Objection to Development Application - RA23/1002 (77 – 83 Princess Street & 120-122 Queen Street, Berry)

This submission has been prepared by Barker Ryan Stewart on behalf of the Berry Forum (community consultative body for the Berry Region). The submission is in response to the notice of proposed development application issued by Shoalhaven Council for the properties at 77 – 83 Princess Street & 120-122 Queen Street, Berry (RA23/1002).

Figure 4: Extract from ePlanning Heritage Map (2023)

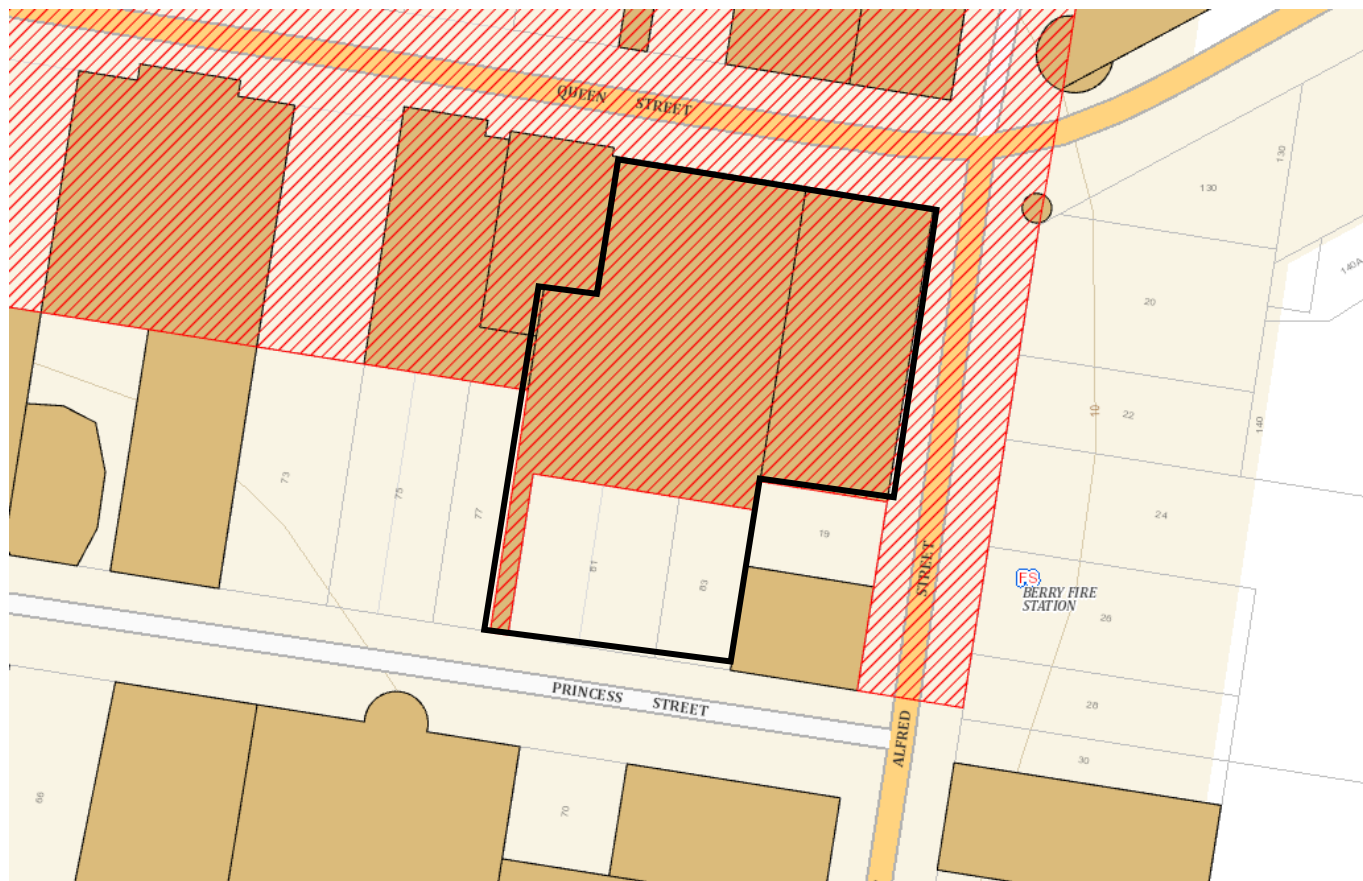
As evident in Figure 4, the new accommodation building will be sited adjacent to a heritage listed dwelling

on the corner of Princess and Prince Alfred Street (item 545 – Federation weatherboard cottage) and immediately opposite St Luke's Anglican Church and associated rectory and garden (items 67 and 68). Further, Figure 4 confirms the surrounding locality accommodates a significant number of heritage items that all contribute to the character of Berry.

Figure 5: Extract from Existing Site/ Survey Plan which can be used to identify the curtilage of the items (H&E Architects, 2023)

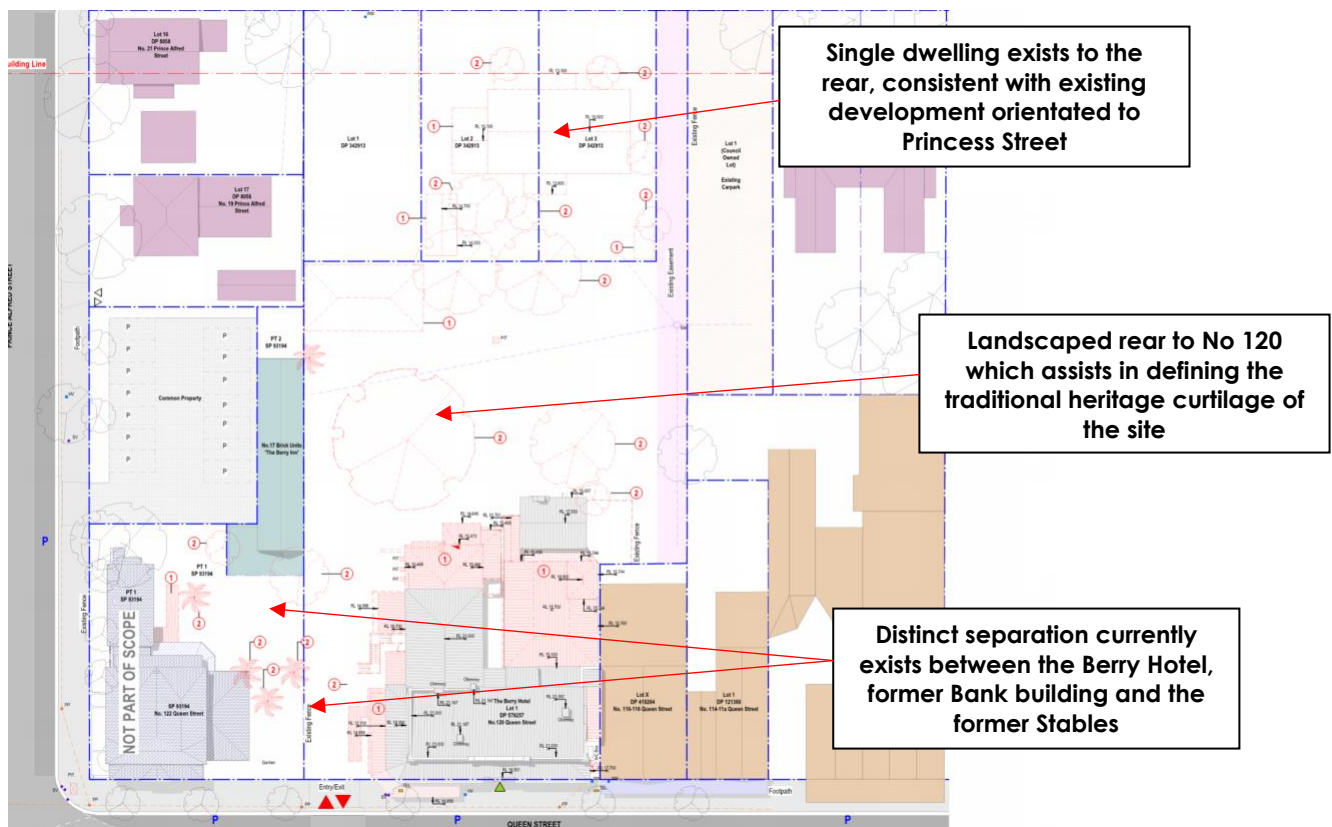
The extract from the existing survey/ Site Plan (Figure 5) and proposed Roof Plan (Figure 6) can be used to identify the scale of additional development for the Pub proposed in the curtilage of two heritage items

and within a Heritage conservation Area. A benchmark of built form separation was traditionally set around historical buildings. This established the heritage curtilage and facilitated an understanding of heritage form and landscaping.

Ultimately the established curtilage between the Berry Hotel and former CBC Bank building should be preserved to ensure these buildings can be appropriately understood. Existing lot boundaries should form an integral consideration in the assessment of this matter given the new pavilion is proposed to extend into the Bank site. Lot layout clearly established the curtilage of historical buildings and should be used as a guide for development of heritage sites. In this instance, the extension of the new built form into the former CBC Bank site results in an unnecessary crowding of both the bank building and the Pub to the detriment of the streetscape.

Figure 6: Extract from proposed Site Plan identifying the level of development proposed to Queen Street frontage (H&E Architects, 2023)

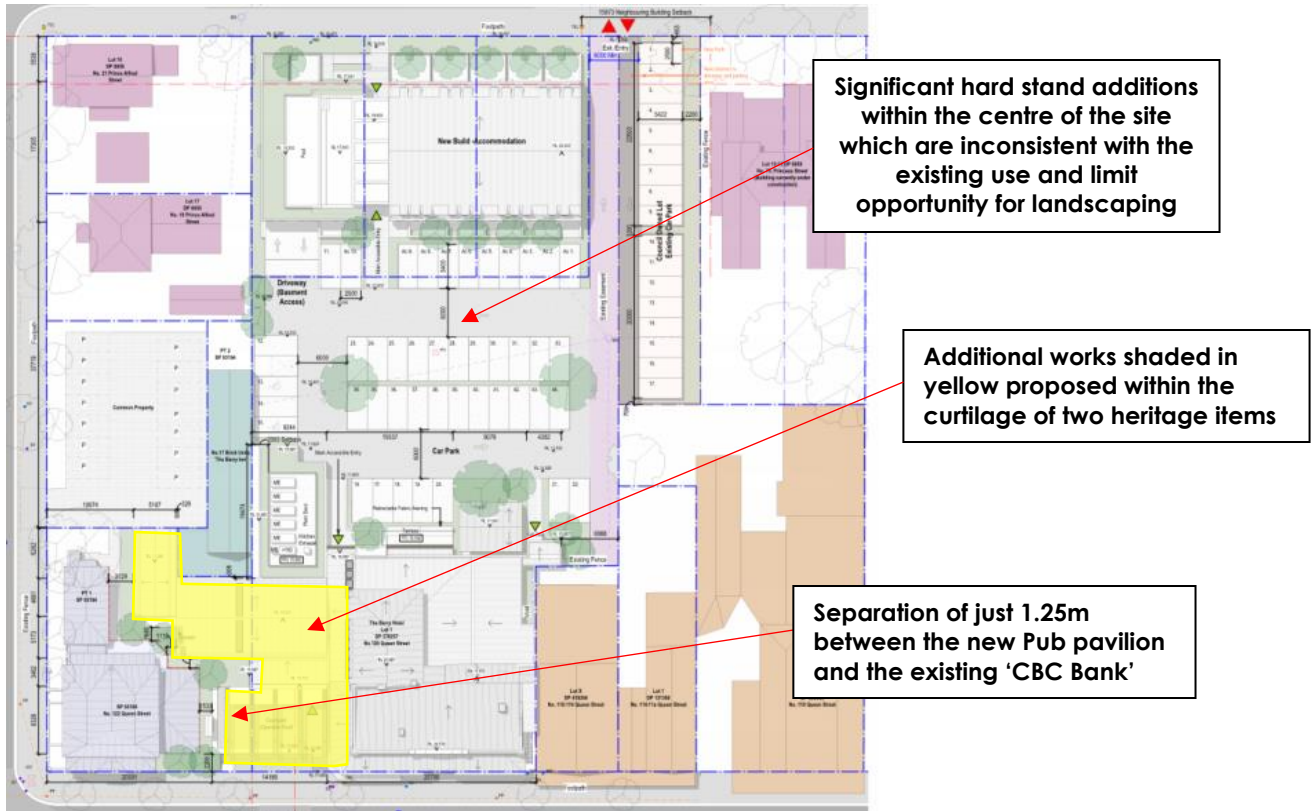
The works to the Berry Hotel include an extension on the eastern side of the existing built form fronting Queen Street that is described as a contemporary pavilion style building. The addition will result in a building separation of just 1.25m to the former CBC Bank on the corner of Prince Alfred Street. Evident in Figures 6 and 7, this inadequate separation will significantly alter the appearance of the Queen Street frontage and impact the understanding of the two buildings that have always stood independently in the streetscape.
